# Re-submittal Form

Case Name/ Number: Ancon / RCU2025-00011
Case Manager: Greg Barnes
Re-submitted Items:
Development Plan/ Site Plan
Plat
X Parking/ Landscape Plan
X Engineering Documents
Subdivision Improvements Agreement (Microsoft Word version)
X Other: Response to Comments

## Ancon Services – CUP Application (RCU2025-00011) 1st response to County Comments

**Application Name:** Ancon Services Colorado Facility

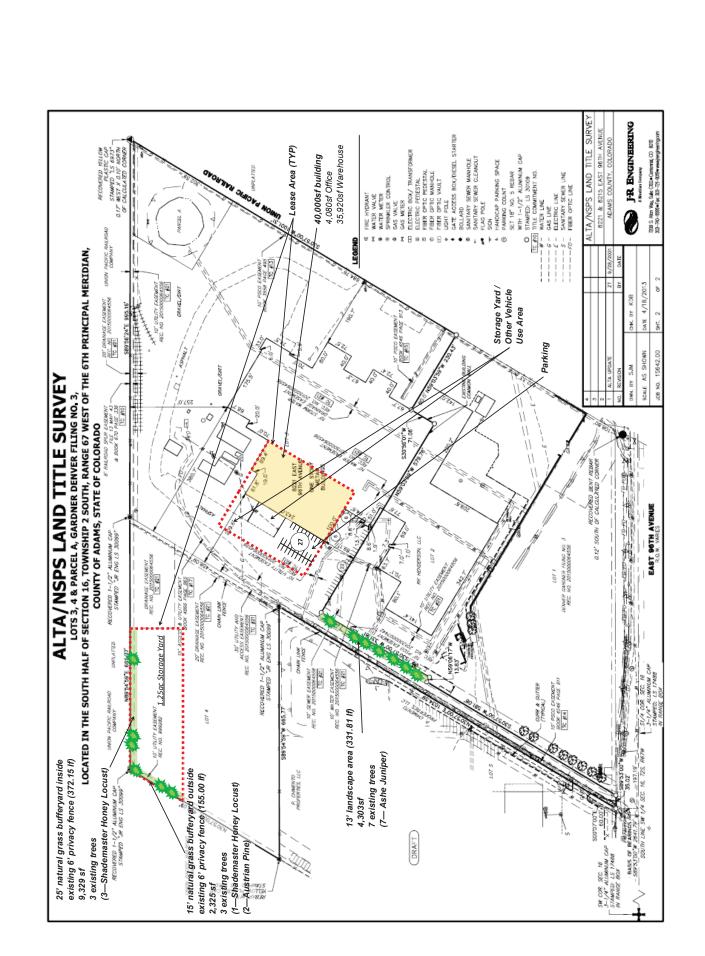
PLN01: Parking / Landscape Plan

The site exhibit has been revised to include a parking plan (sheet 1) and an existing landscape plan (sheet 1). A site data table has also been included (sheet 2). We have identified the following variance / relief requests.

- 1. PARKING: Allow 27 parking spaces where 29 parking spaces are required. While the site has sufficient parking to accommodate all users, Ancon's leased premises only contains 27 parking spaces. We are certain that the 27 parking spaces provided will accommodate Ancon's 11 employees. This site is not open to the public.

- 2. LOT LANDSCAPING: Relief from the requirement to place 50% of the required landscaping adjacent to the public right-of-way. This property only has 35 feet of adjacency to the public right-of-way. The entire frontage is comprised of a shared access drive. The street frontage is not part of Ancon's leased premises, and we are not certain this requirement applies. We are requesting this relief out of an abundance of caution. We would like to note that as required, 10% of the leased premises is landscaped within the bufferyards on the north and west sides of the 1.25 acre storage yard.

3. STREET FRONTAGE: Allow 7 existing trees in a 13'x331' landscape strip (4,303sf) along the east side of the shared driveway in lieu of street frontage landscaping adjacent to the right-of-way where 350sf, 2 trees and 5 shrubs are required. The street frontage is not part of Ancon's leased premises, and we are not certain this requirement applies. We are requesting this relief out of an abundance of caution.

4. PARKING LOT: Allow the 6 existing trees in north and west bufferyards adjacent to the 1.25 acre storage yard in lieu of parking lot trees, where 3 trees are required. Bufferyards and trees are not required where industrial uses abut industrial uses, however, these landscape features are already in place. We are requesting this allowance given the existing nature of the paved parking area and the limited space within Ancon's leased premises to plant additional trees. Adjacent industrial uses are:

5. PARKING LOT: Allow 4,303sf of landscape area along the shared driveway in lieu of parking lot landscaping where 486sf are required. We are requesting this relief given the existing nature of the paved parking area and the limited space within Ancon's leased premises to plant additional trees. The parking lot is not visible from off-site.

6. OTHER VEHICLE AREAS: Allow 4,303sf of landscape area along shared driveway in lieu of other vehicle area landscaping where 6,186sf are required. We are requesting this relief given the existing nature of the paved parking area and the limited space within Ancon's leased premises to plant additional trees. These other vehicle areas are not visible from off site.
